DOCKETED	
Docket Number:	24-BSTD-01
Project Title:	2025 Energy Code Rulemaking
TN #:	256323
Document Title:	Western Propane Gas Association Comments - WPGA Comments on 2025 Energy Code Rulemaking
Description:	N/A
Filer:	System
Organization:	Western Propane Gas Association
Submitter Role:	Other Interested Person
Submission Date:	5/13/2024 1:22:51 PM
Docketed Date:	5/13/2024

WPGA Comments on 2025 Energy Code Rulemaking

RE: 2025 Building Code Standards

Single-Family Heat Pumps

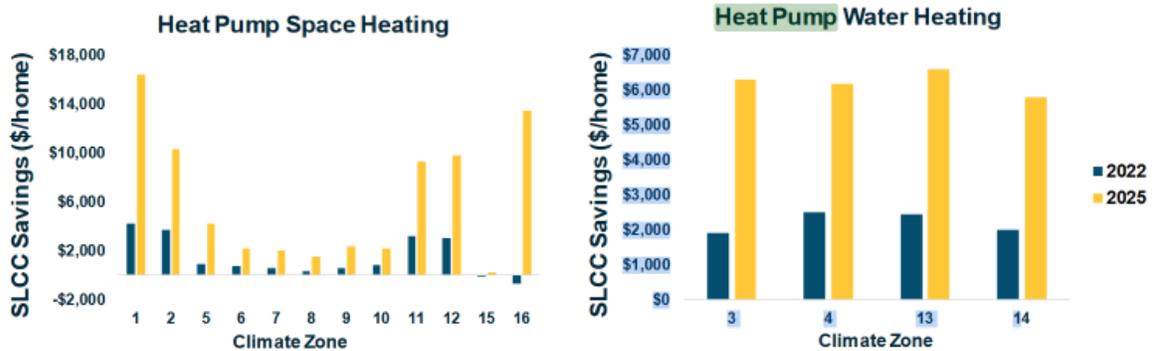
risk furthering this crisis deserves only the utmost of scrutiny. The figure below shows the impact of the change in the CEC's energy accounting from the 2022 Code to the 2025 Code.

- Switching from natural gas space heating baseline to electric heat pump generates SLCC savings in all climate zones, ranging from **\$200-\$16,400** per home (left graph)
- Switching from natural gas water heating baseline to electric heat pump generates SLCC savings in all climate zones, ranging from **\$5,800-\$6,600** per home (right graph)

Residential Gas

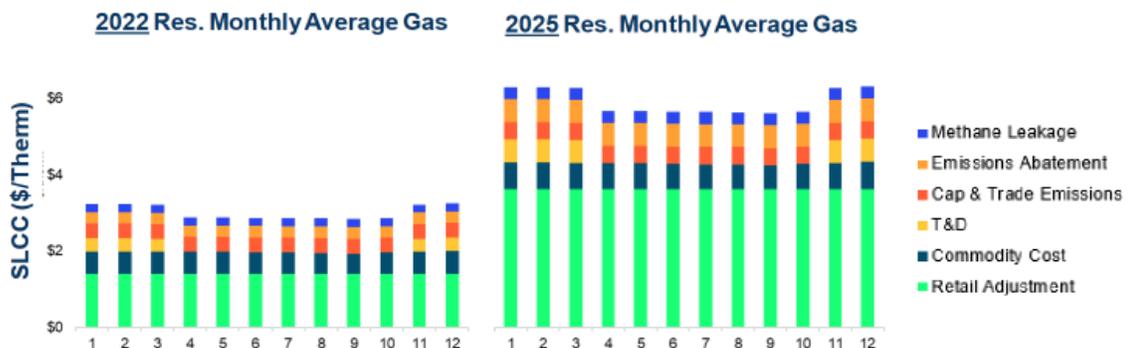
This analysis begins with the CEC's choice to use a high electrification adoption model as their baseline, causing a presumed large scale cost increase for natural gas as seen in the figure below.

Residential gas factors significantly higher than 2022 cycle, mainly due to increases in retail adjustment from high electrification (**80% increase** in residential gas factors)

This single assumption causes an 80% retail price increase for natural gas. This assumption ignores propane and the fact that propane does not suffer cost increases due to aging and abandoned infrastructure, and does not account for the proportionately higher use of propane in rural and heating dominated climate zones. This assumption is also highly vulnerable to the fact that energy prices are notoriously difficult to forecast.
